# **Recall Campaign**

January 2023
FL928 AB
NHTSA #22V-271 (School Bus)
NHTSA #22V-272 (Non-School Bus)
Transport Canada #2022-207 (School Bus)
Transport Canada #2022-208 (Non-School Bus)

Subject: TBB HDX Battery Cables

Models Affected: Specific model year 2019-2023 Thomas Built Buses (TBB) HDX model buses, manufactured March 8, 2018, through March 24, 2022.

Fig. 1, Blemishes on the Power Cables and the Cooler Hoses

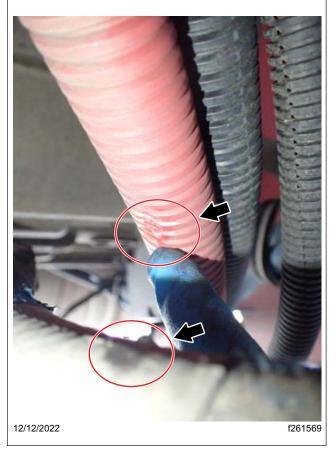
6. Inspect for any blemishes caused due to interference (rubbing) between the power cables and the transmission cooler hoses. See Fig. 1 and Fig. 2.

Fig. 3, Ideal Positioning of the Cables, Clamps, and Hoses

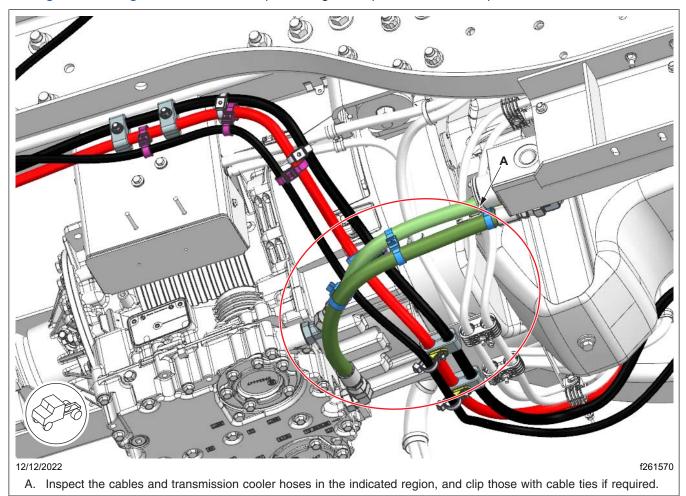
10. Figure 3 and Figure 4 show the ideal positioning of the power cables, clamps, and transmission cooler hoses.

Fig. 5, Transmission Cooler Hose Clamp Removal

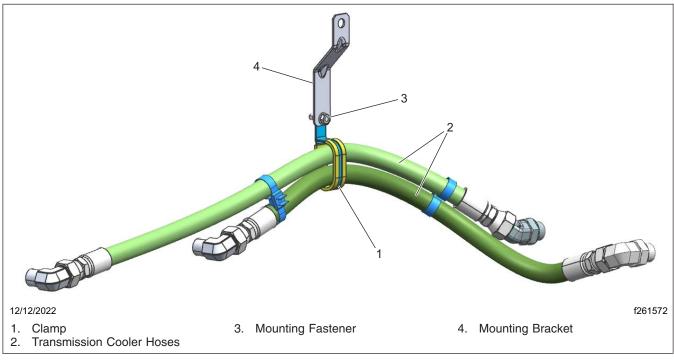
If so equipped, remove and discard the clamp securing the transmission cooler hoses, shown in **Fig. 5**, by removing the mounting fastener.

Fig. 6, Maintaining Clearance between the Hose and the Hose Fitting (Allision 3000-series transmission shown)

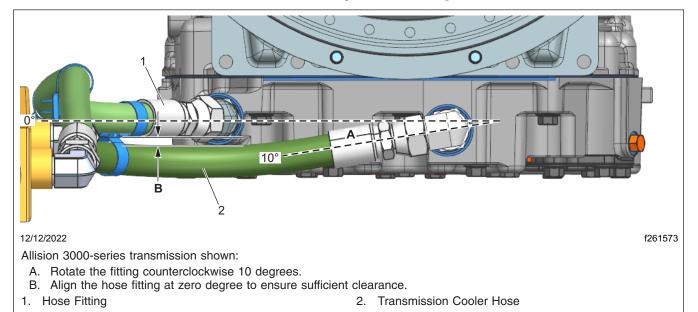
12. If necessary, loosen the transmission cooler hose fittings at the transmission, then position the hoses to maintain clearance between the hose and the hose fitting as shown in **Fig. 6**.

Fig. 7, Securing the Transmission Cooler Hoses

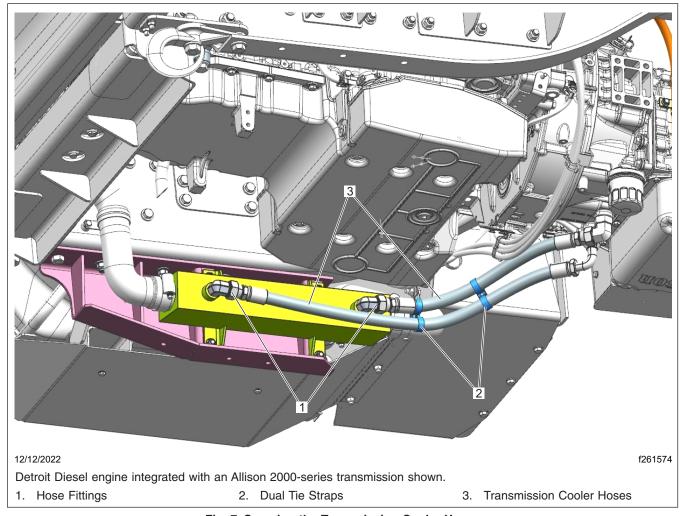
Route and secure the cooler hoses as shown in Fig. 7.

14. If necessary, loosen the transmission cooler hose fittings, and rotate the hoses slightly to ensure zero contact between the power cables and the cooler hoses.
